Staff Report

Land Division – Tentative Partition Plat

PA-01-19

March 27, 2019

PROPOSED PARTITION PLAT

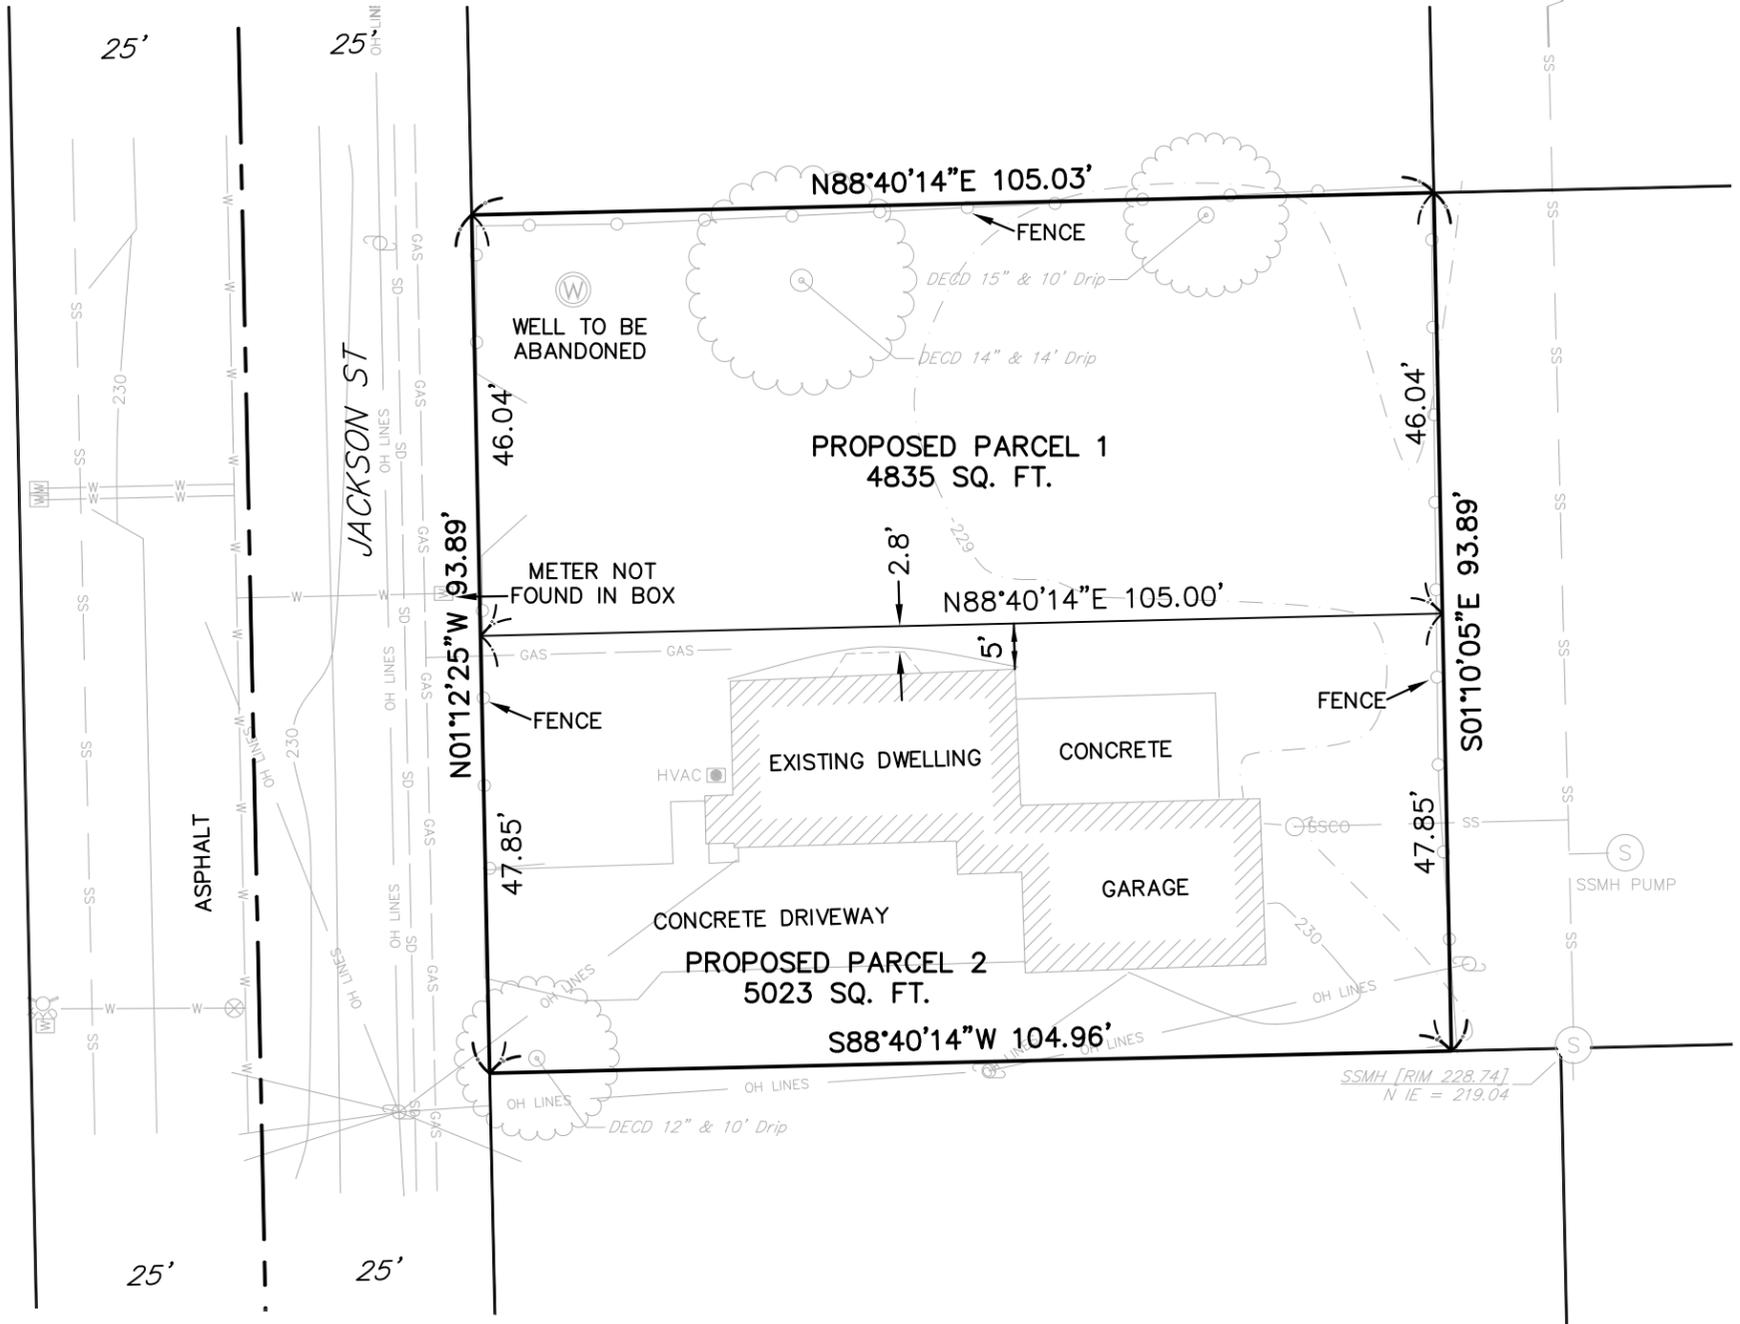
- 1.1 The subject lot is located in the Residential Medium Density (RM) zoning district. The RM district is intended primarily for medium- to high-density urban residential development. Development may not exceed 25 units per gross acre.
- 1.2 The proposed partition will result in two lots (Attachment B.2). Parcel 2 will contain the existing residence. Development of Parcel 1 is not proposed with this application.
- 1.3 The minimum lot width for the RM zone is 30 feet for detached units and 20 feet for attached units. The minimum lot depth is 60 feet. Parcel 1 has a minimum width of 46.04 feet and a minimum depth of 105 feet. Parcel 2 has a width of 47.85 feet and a minimum depth of 104.96 feet. Therefore, as proposed both lots meet the minimum lot width and depth requirements.

- 1.4 The minimum lot area in the RM zone for a single-family detached structure is 3,500 square feet. The minimum lot area for a duplex is 4,800 square feet. As proposed, Parcel 1 has a total lot size 4,835 square feet. Parcel 2 has a total lot size of 5,023 square feet. Therefore, as proposed both lots meet the minimum lot size for a single-family or duplex unit.

- 1.6 The RM zone requires a minimum interior setback of 3 feet for single-story structures and a minimum of 5 feet for two or more stories. The existing building on Parcel 2 is 1.5 stories, with a dormer window located on the north side of the house. Because the upper floor contains windows, a 5-foot interior setback is required. The existing residence is approximately 7.5 feet from the south interior property line, 18 feet from the east interior property line, and 5 feet from the interior property line to the north that will be created through the partition. Therefore, Parcel 2 meets the interior setback requirements of the RM zoning district.

- 1.7 ADC 3.260 (2) allows projecting building features, including bay windows, to encroach into the interior setback up to 2 feet. The existing residence has a bay window on the north side of the building that encroaches 2.2 feet into the required 5-foot interior setback. Because the bay window is located on the first floor the single-story interior setback of 3 feet will be used, which allows the bay window to be as close as 1 foot from the interior lot line. As proposed, the bay window is 2.8 feet from the interior lot line and therefore meets the setback standard.

- 1.8 The Oregon Residential Specialty Code requires a minimum of 3 feet of separation between residential structures and property lines. As proposed, the bay window will be 2.8 feet from the property line. Either the property line would need to be adjusted so that the building is no closer than 3-feet to the property line or the window opening would not be allowed. Additionally, the wall and roof overhang will need to be protected as required in Table R302.1, when either is within 3 feet of the property line.

- Condition 1 Before the City will approve the final partition plat, the applicant shall either adjust the property line to allow 3 feet between the bay window and roof overhang to the north property line or apply for a building permit to meet the separation requirements of the Oregon Residential Specialty Code.
